**TO:** Scott Boduch, Rogue Architecture  
**FROM:** BrieAnna Simon, Associate Planner  
**DATE:** February 17, 2022  
**SUBJECT:** Horseshoe Ridge AMD 1 L2 B1 - Commercial Multitenant  
Site Plan Adjustment – SP22-007 Review Comments v1

# HORSESHOE RIDGE SUBDIVISION 1ST AMENDMENT

# PARKER MIXED-USE RETAIL

SHEET: **A-1**

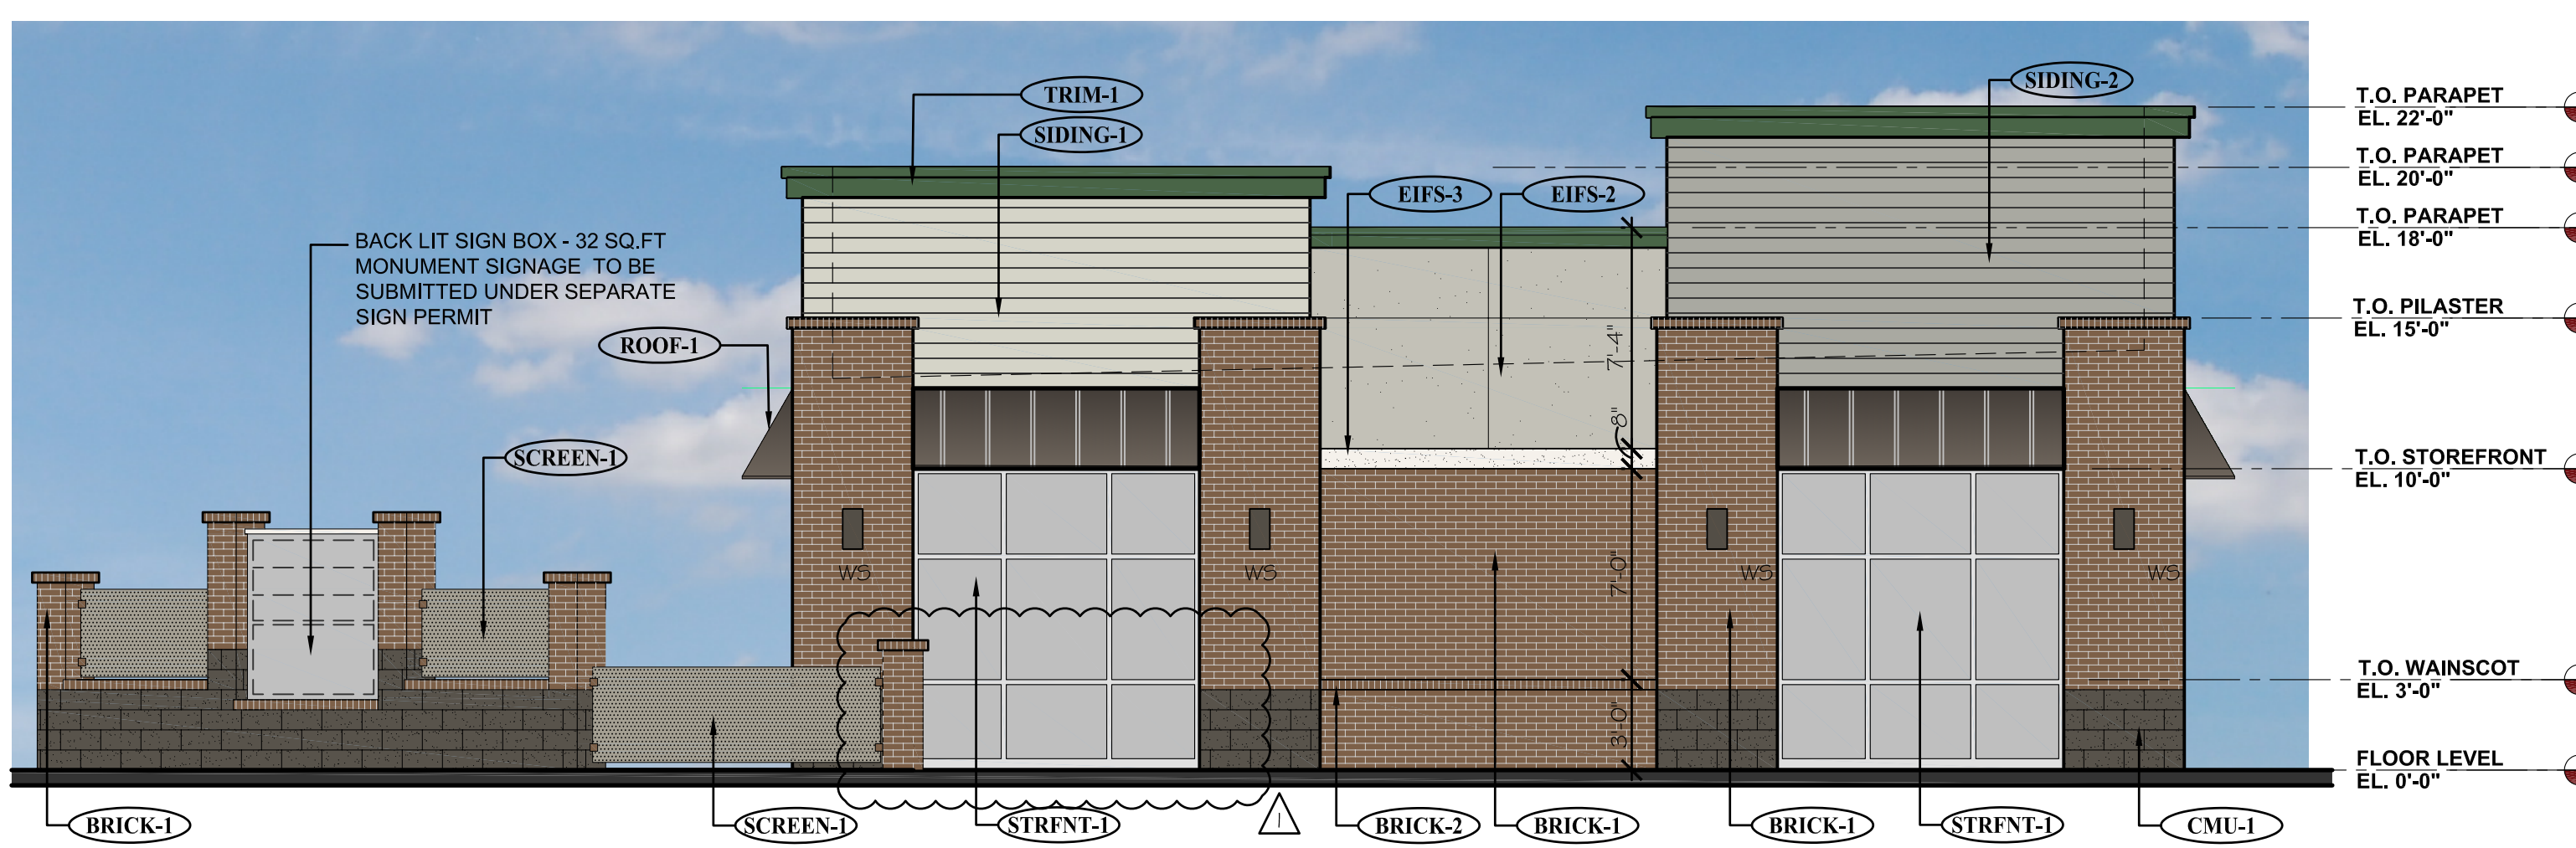
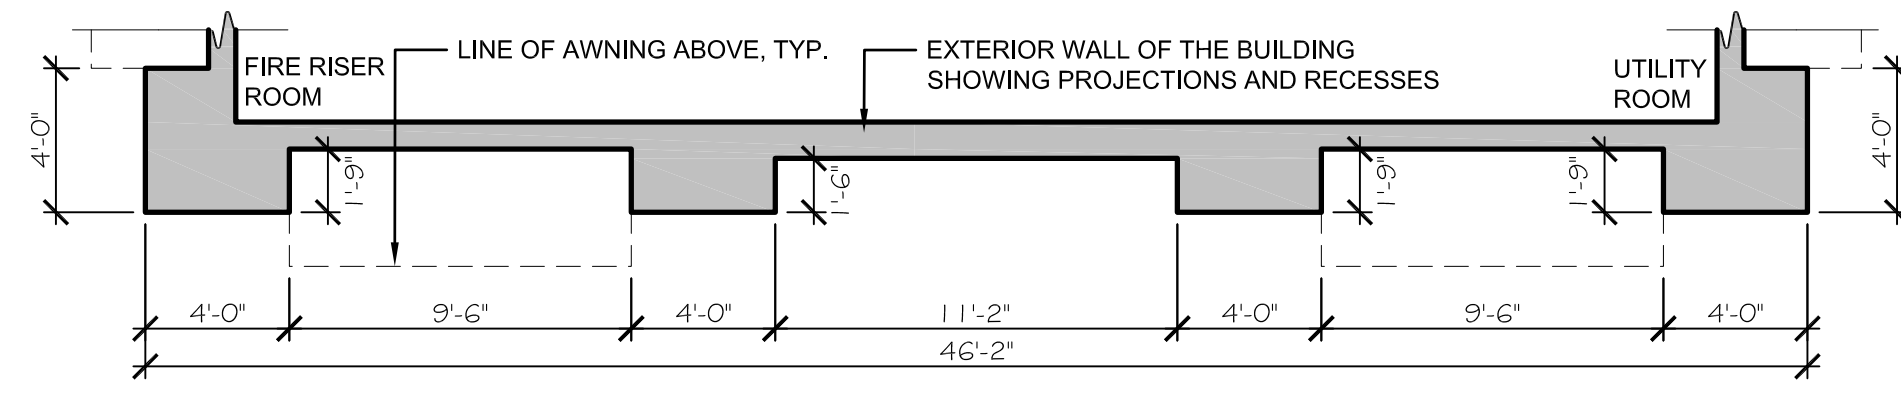
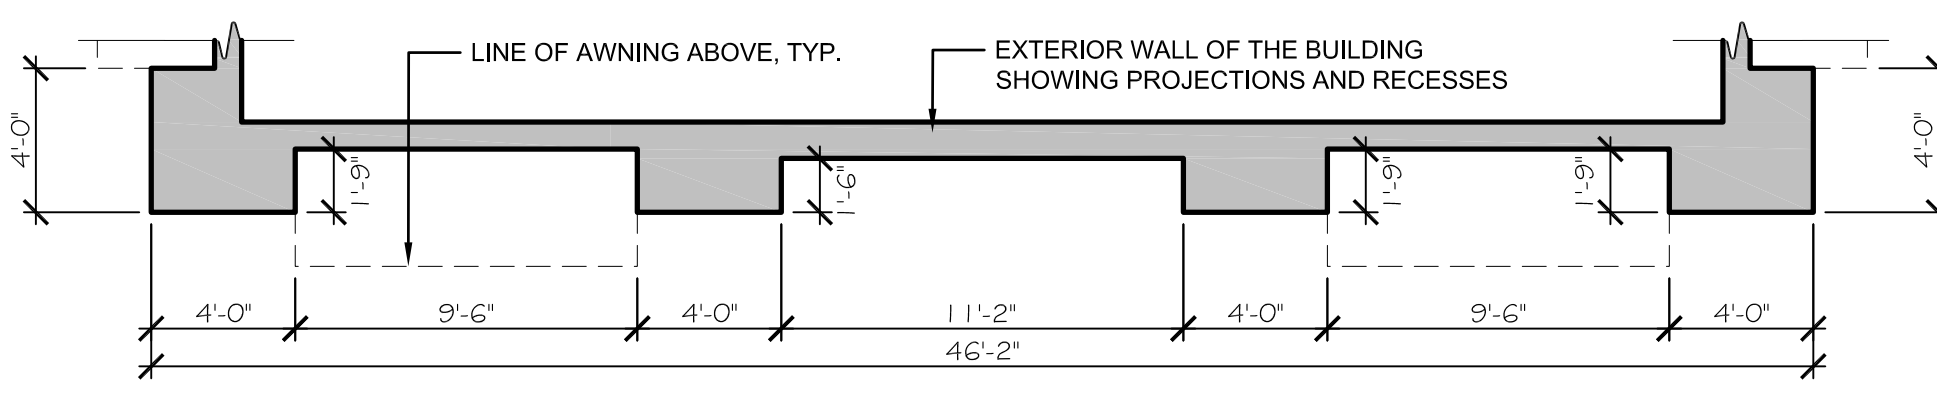
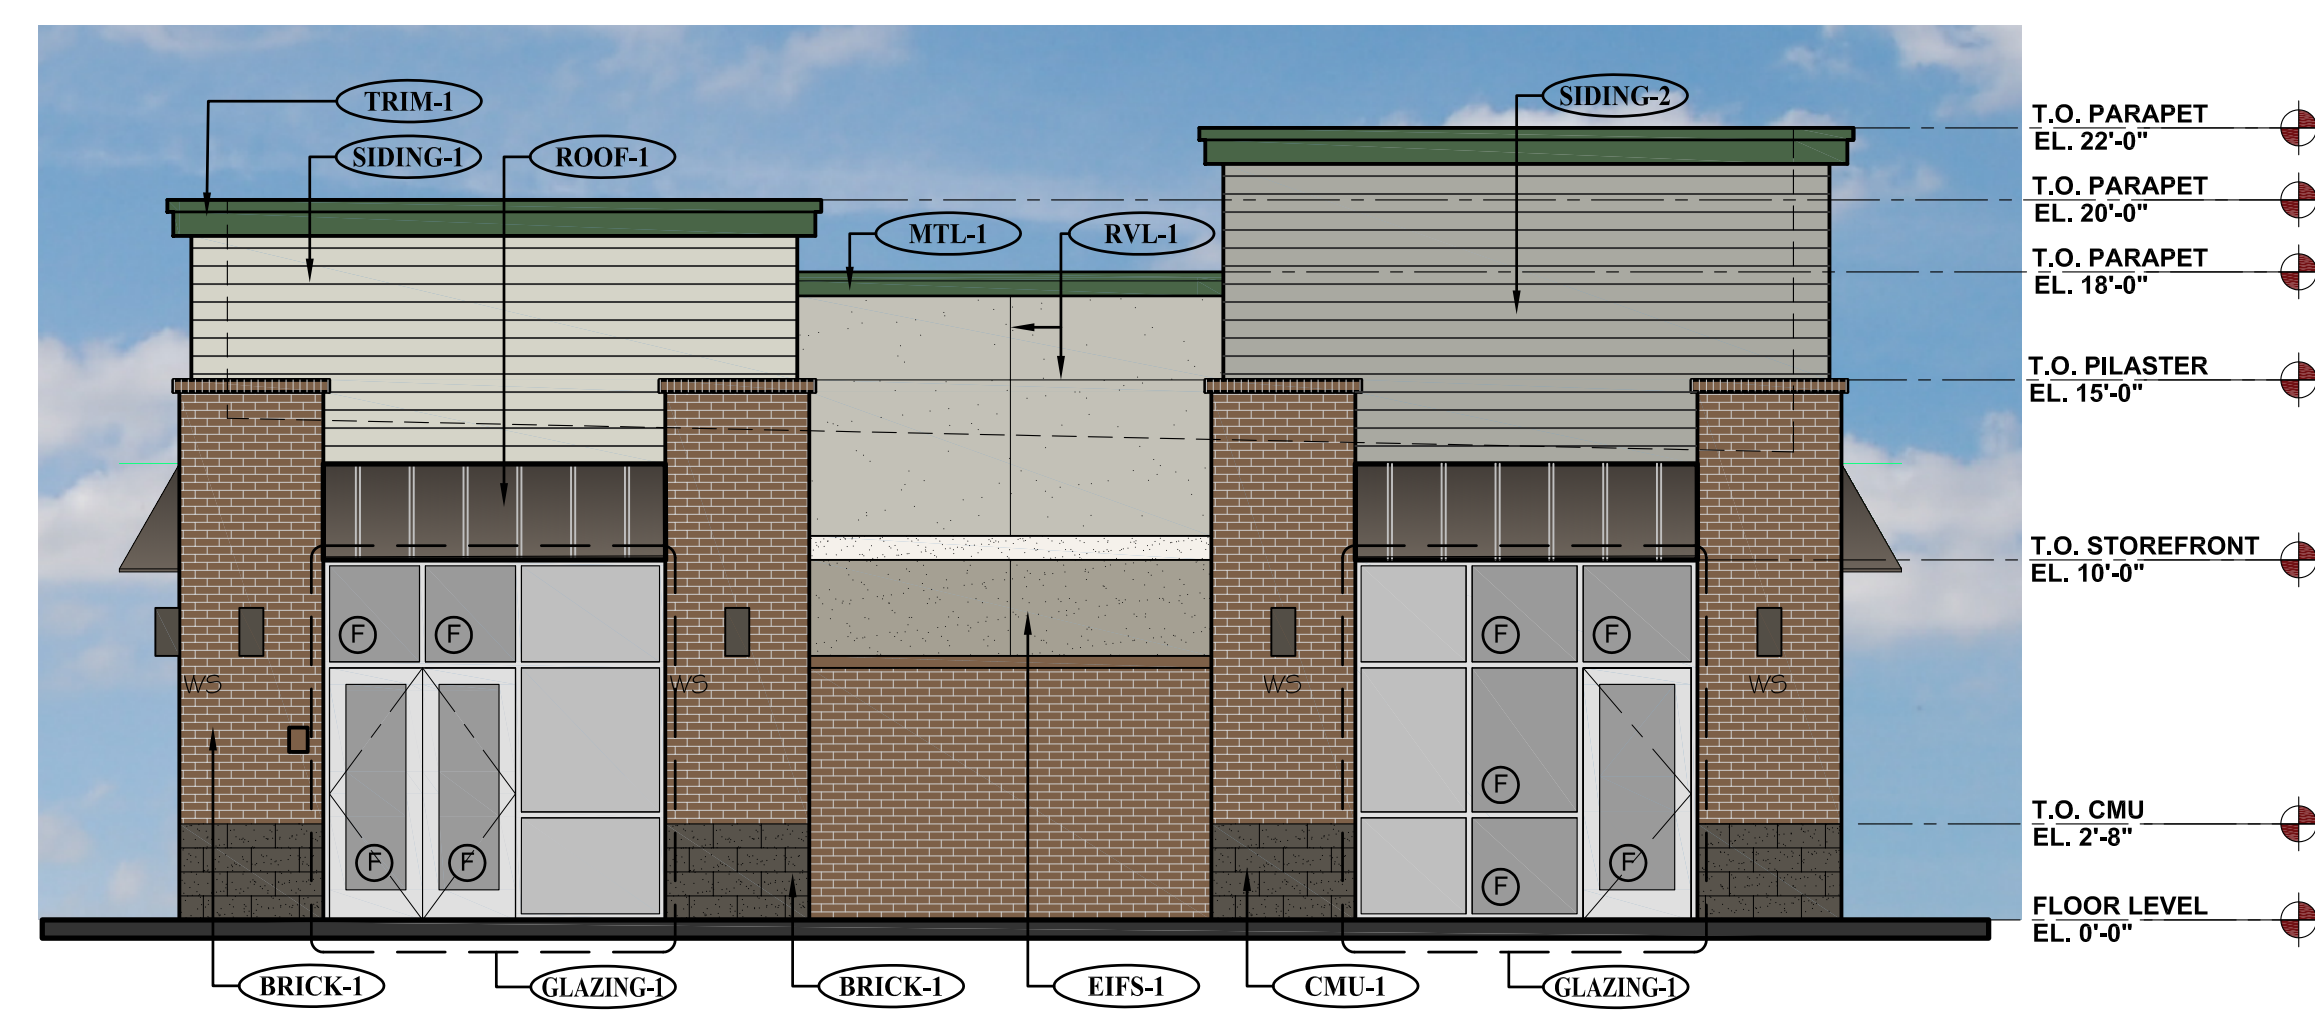
Please be sure the window types (Storefront 1 and Glazing 1) match the building permit.
